PART 1 - ADDENDUM

- 1.1.1. This Addendum is issued to provide for modifications and/or clarifications during Bidding and forms part of Bid and Contract Documents for above Project.
- 1.1.2. Except as otherwise specified herein, or as shown on accompanying Drawings, work required by this Addendum shall be in accordance with Specifications dated January 31, 2025, Drawings accompanying same and previously issued Addenda.

UNIVERSITY OF TORONTO
**HEALTH & WELLNESS CENTRE
 AT KOFFLER RENOVATION**

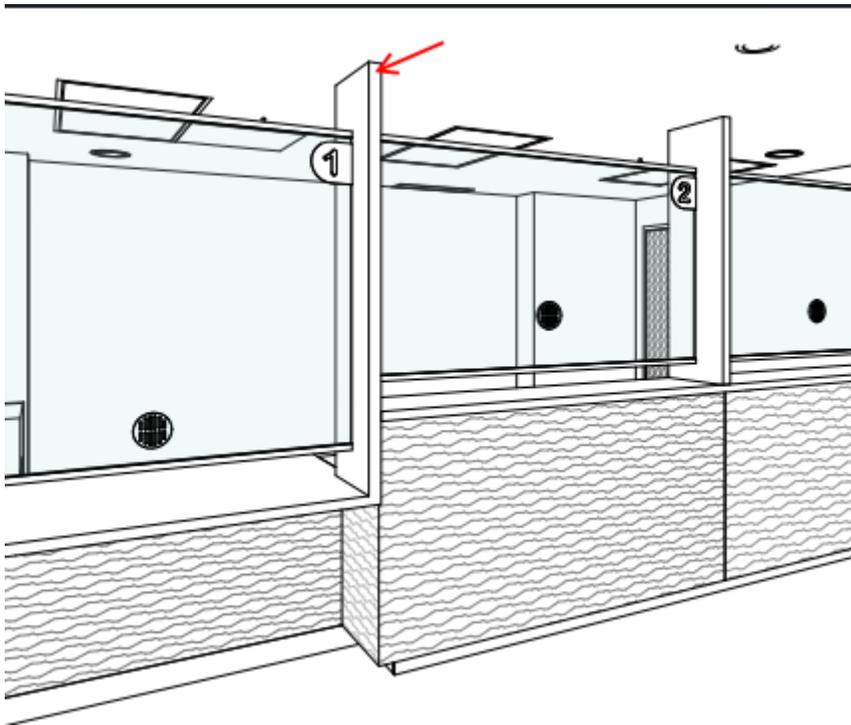
3.1.1.4.1. Question: Can the architect confirm if these vertical panels are to match the countertop and extend to the wall, supplied by the millwork sub-contractor.

3.1.1.4.2. Answer: The materials of the vertical panels do not match the countertop finish. Refer to the WP-3 and WD-3 materials shown in detail 12/A820.

PROJECT NUMBER:
23-011 (P143-19-100)
 DRAWING SCALE:
1:50
 DRAWN BY: **AF** CHECKED BY: **AF** DATE: **2025-01-31**
 SHEET NO:
A211

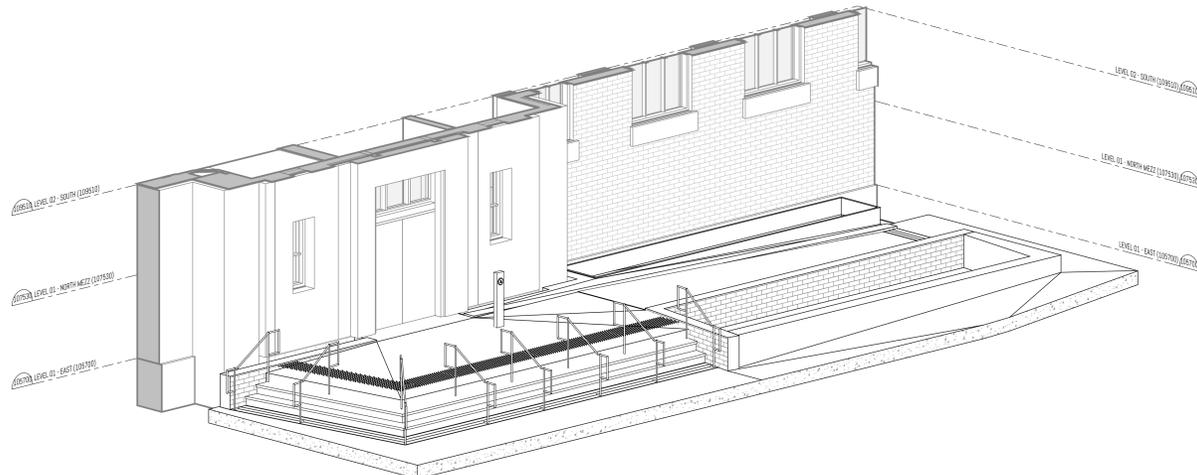
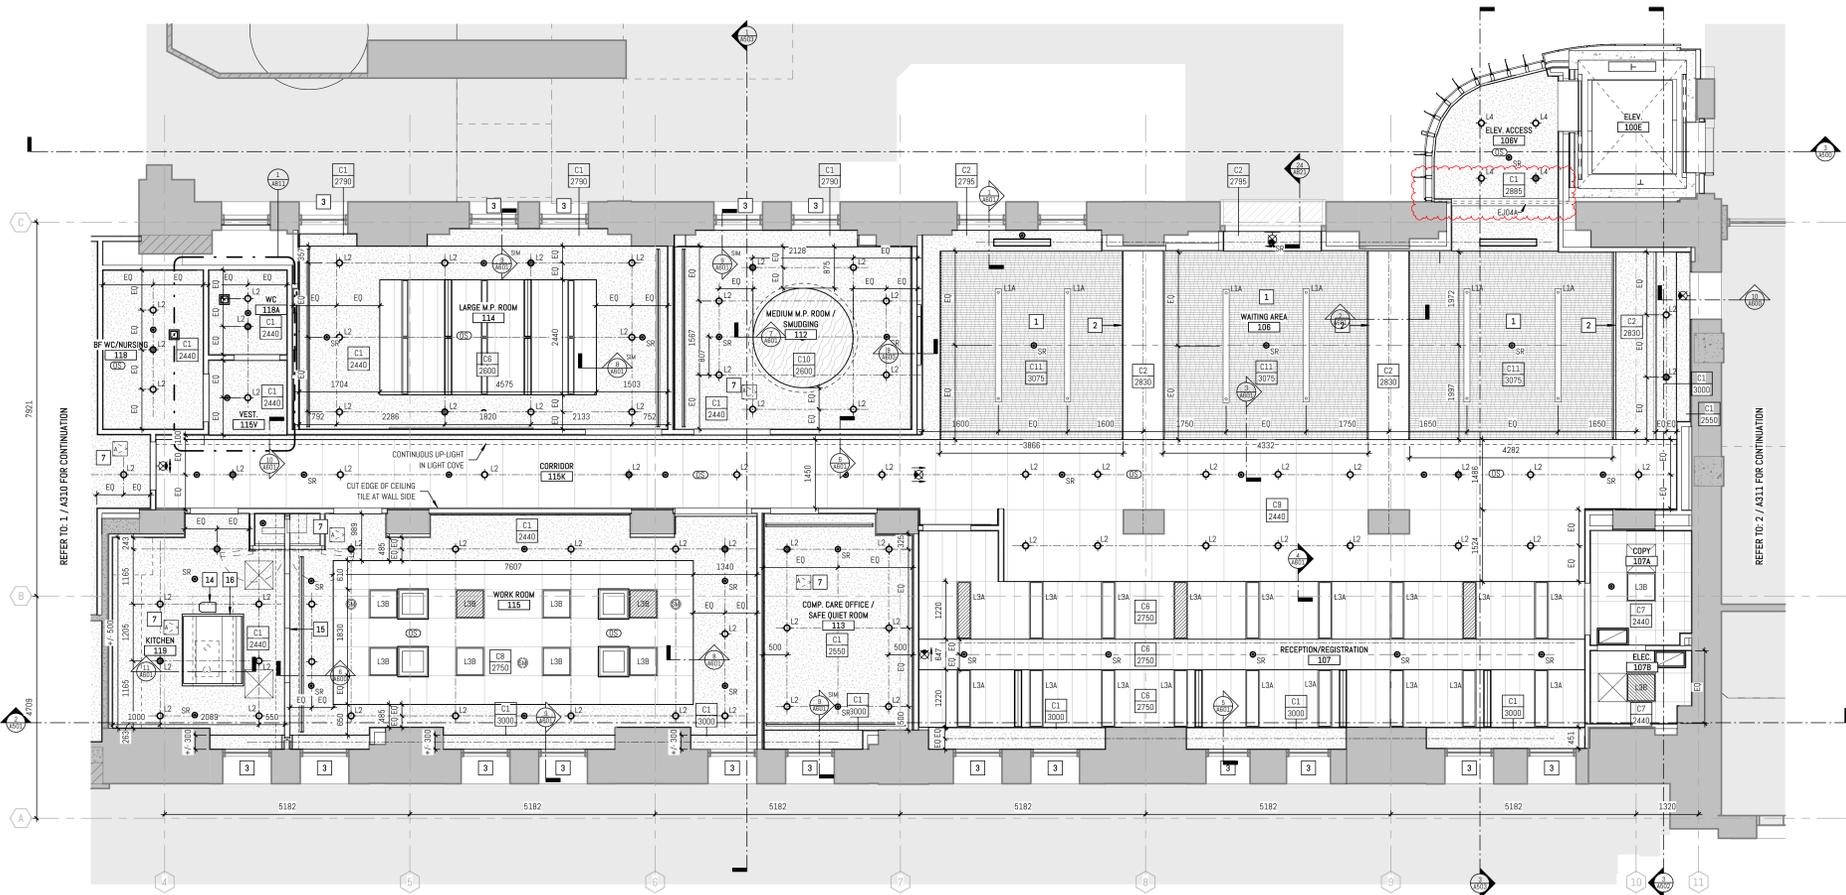
- 4.1.1. Drawing No. A211 attached is modified as follows:
- 4.1.1.1. "Detectable Warning Surface" note changed to "4 mm high type 316 stainless steel truncated domes 22 mm in diameter with concentric rings centre dome pattern fastened to the granite pavers".

SHEET NO:
A310

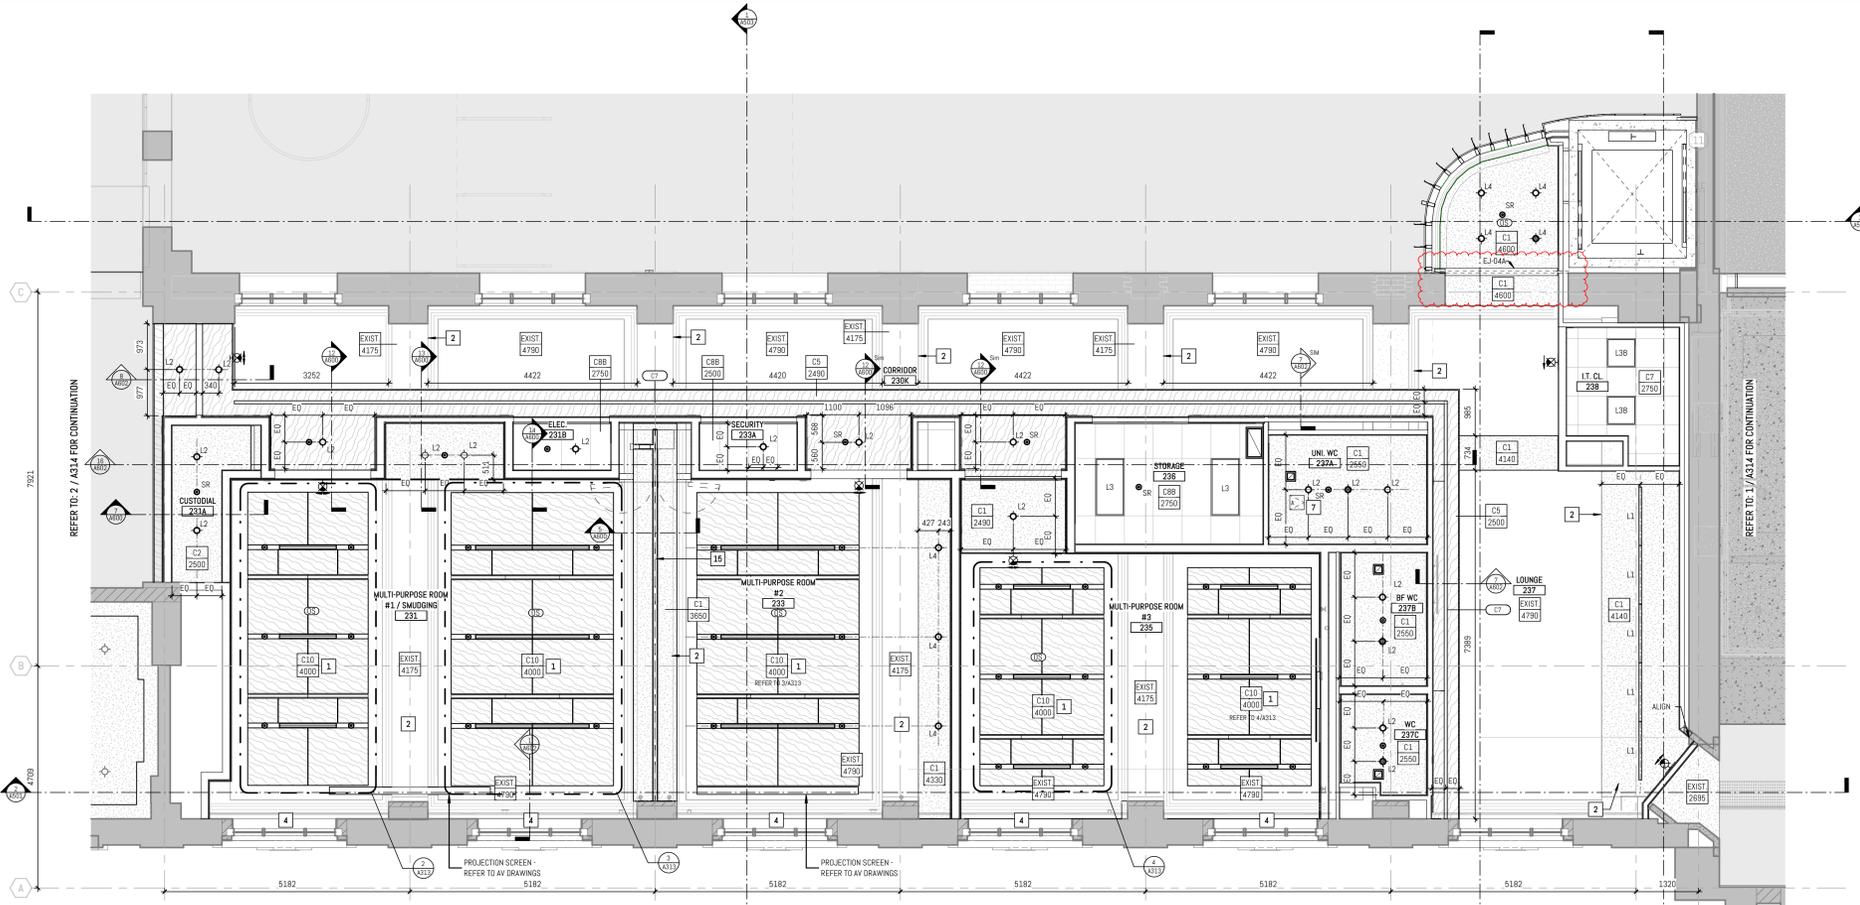
- 4.2.1. Drawing No. A310 attached is modified as follows:
- 4.2.1.1. Added ceiling expansion joint location at ELEV. ACCESS 106V

SHEET NO:
A313

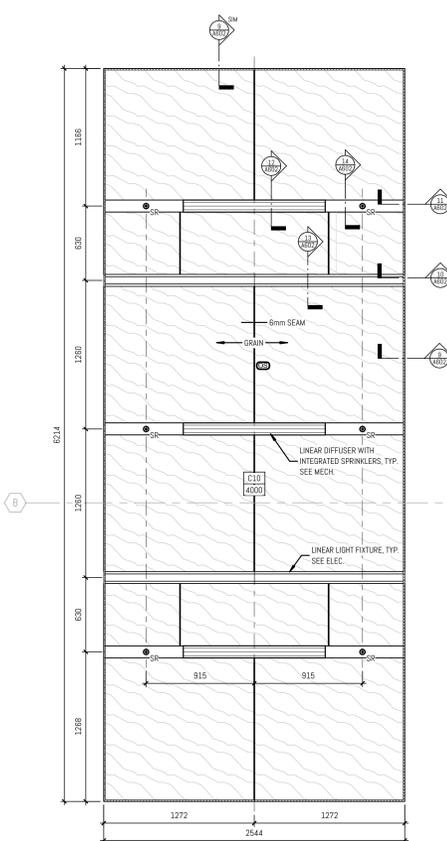
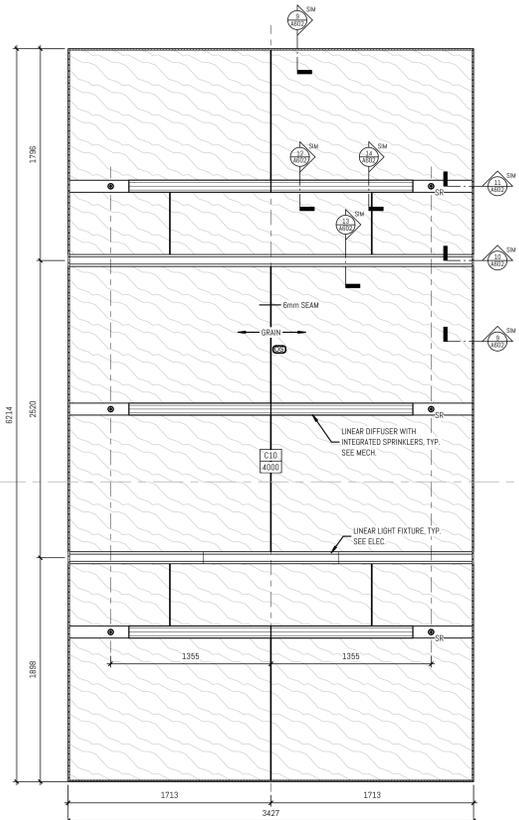
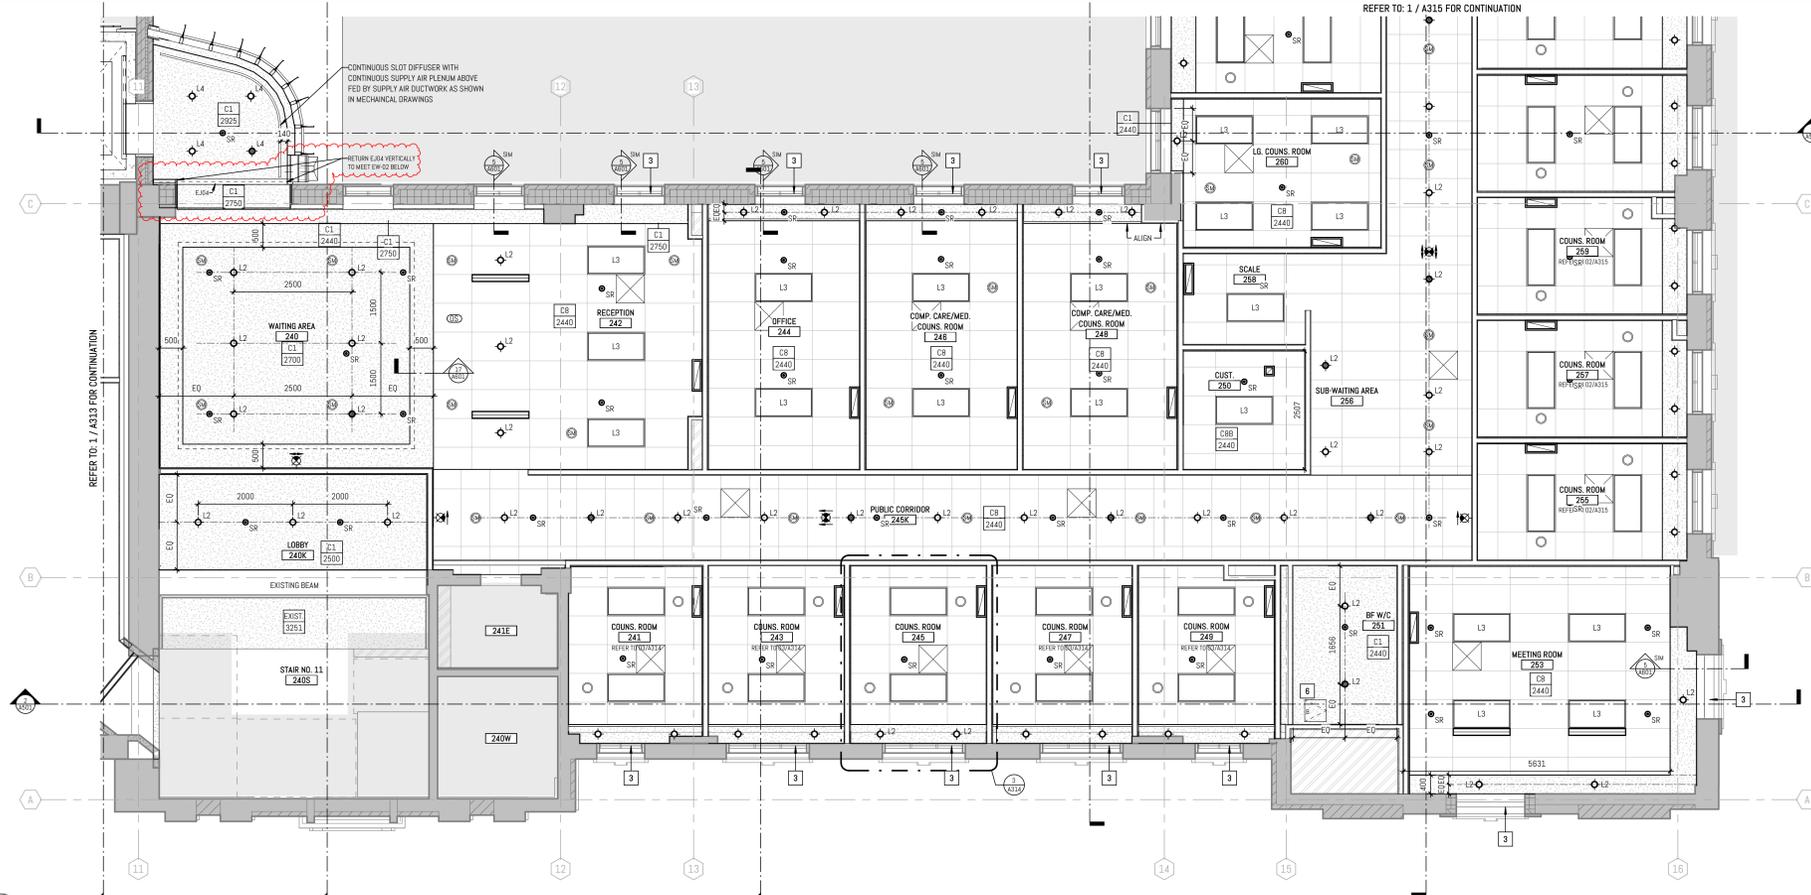
- 4.3.1. Drawing No. A313 attached is modified as follows:
- 4.3.1.1. Added ceiling expansion joint location at Elevator Landing.

SHEET NO:
A314

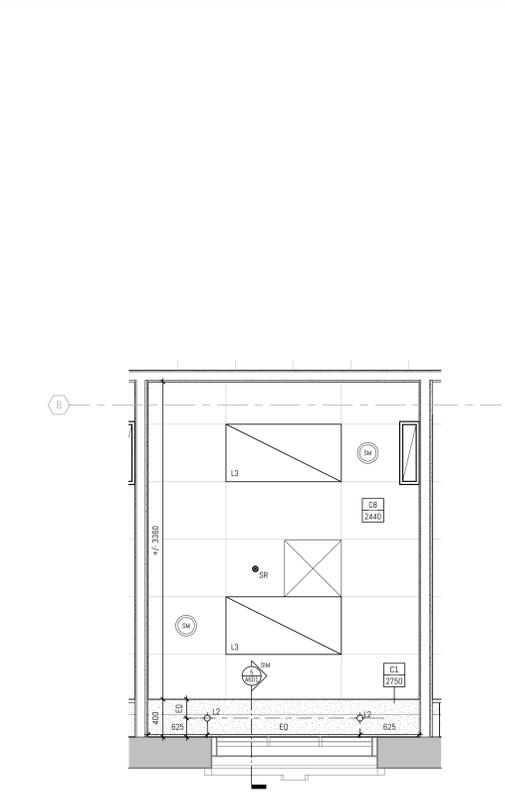
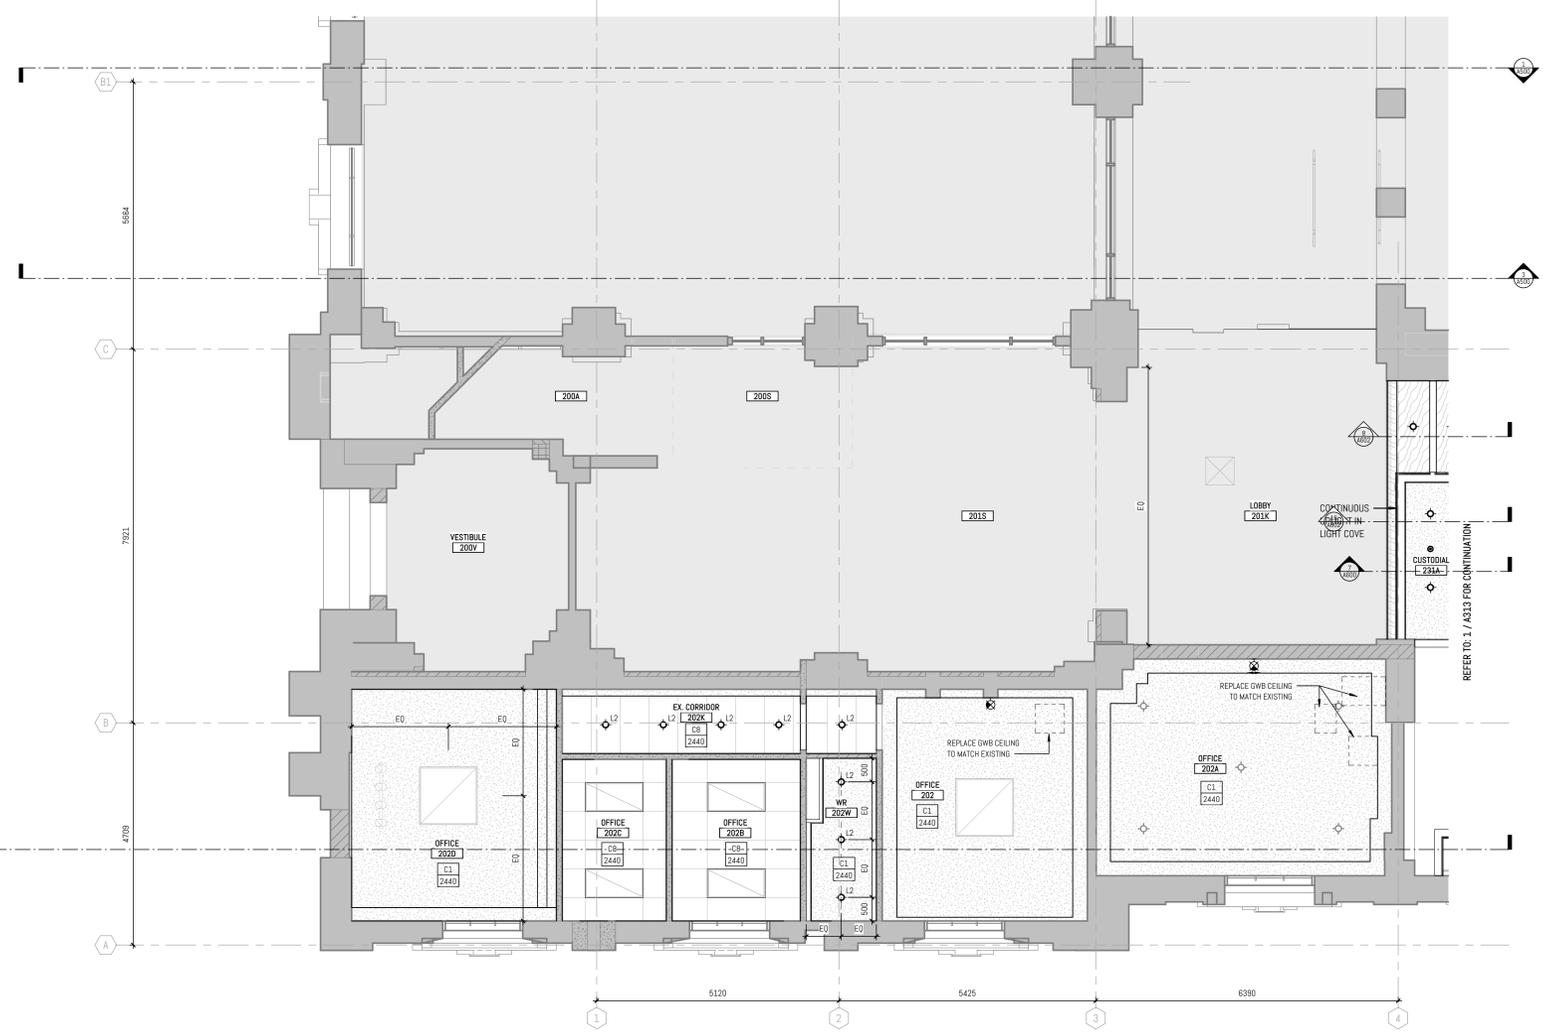
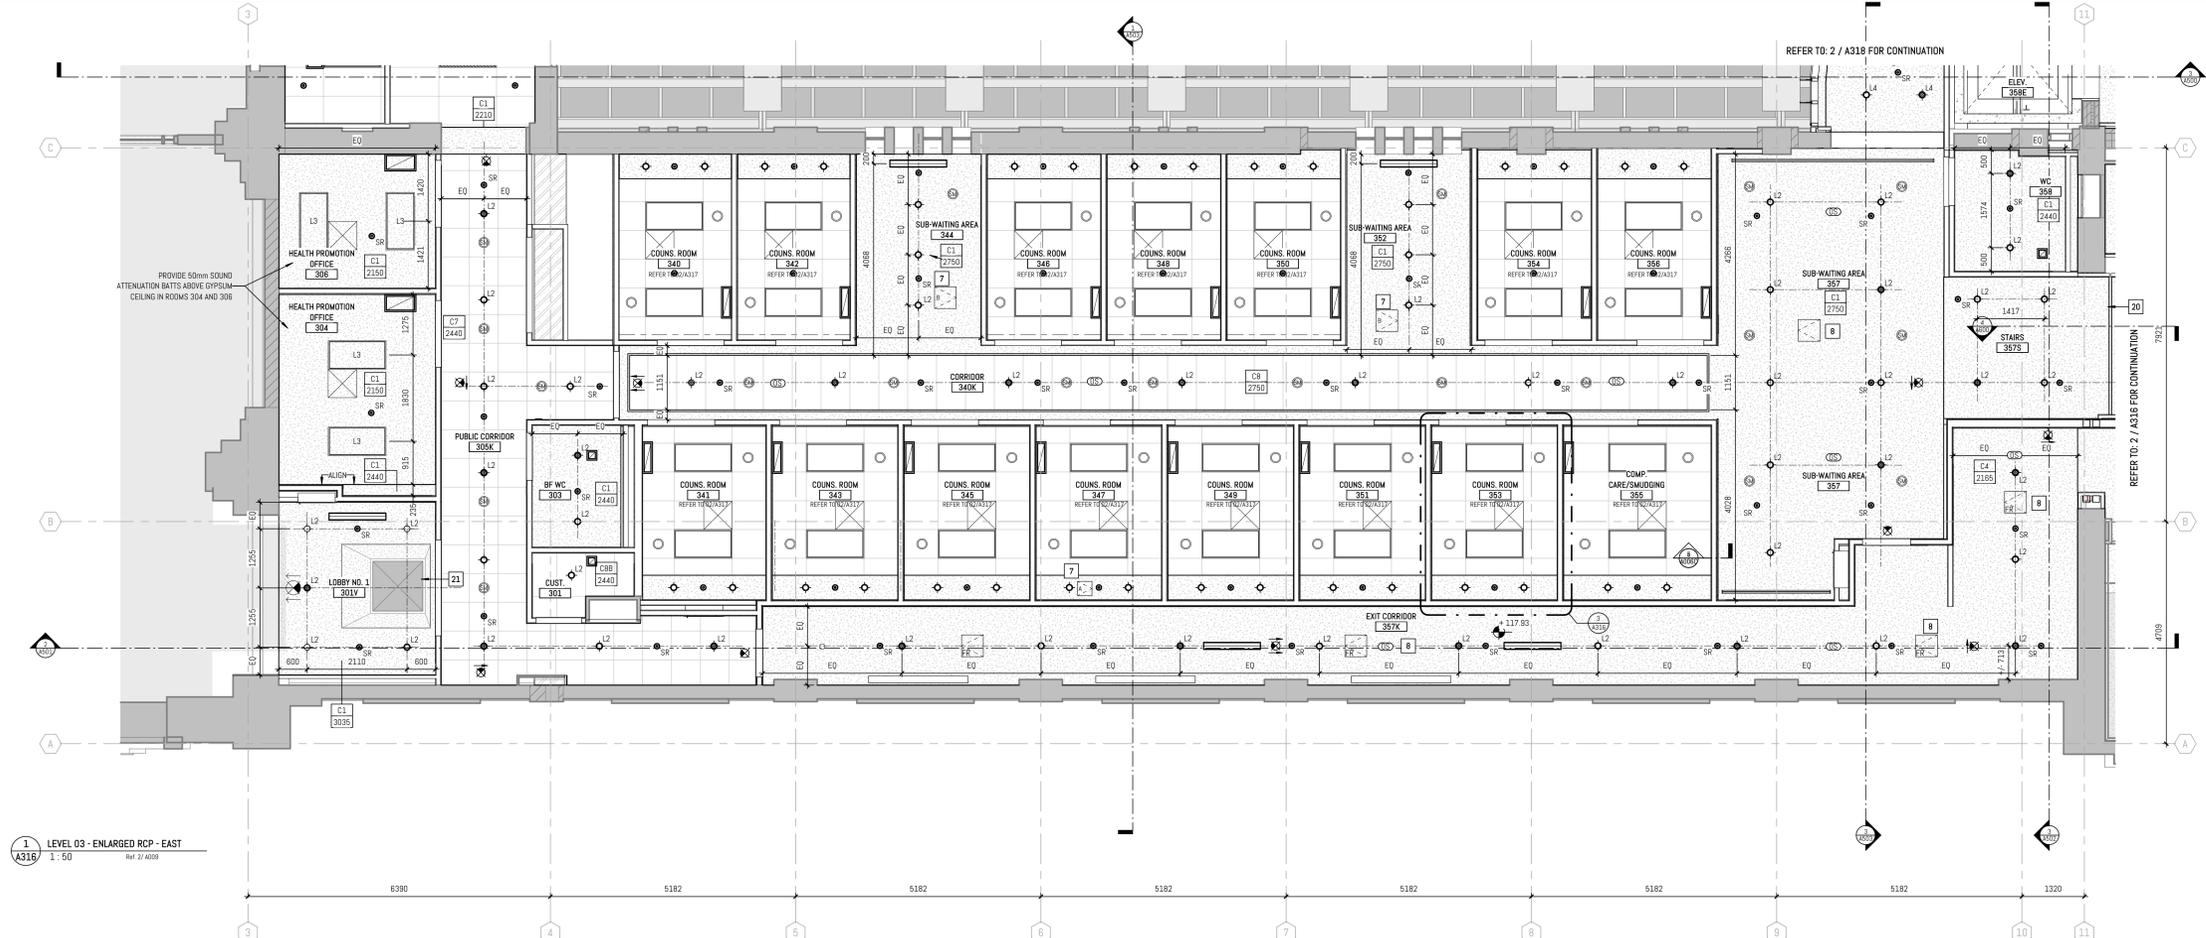
- 4.4.1. Drawing No. A314 attached is modified as follows:
- 4.4.1.1. Added ceiling expansion joint location at Elevator Landing.
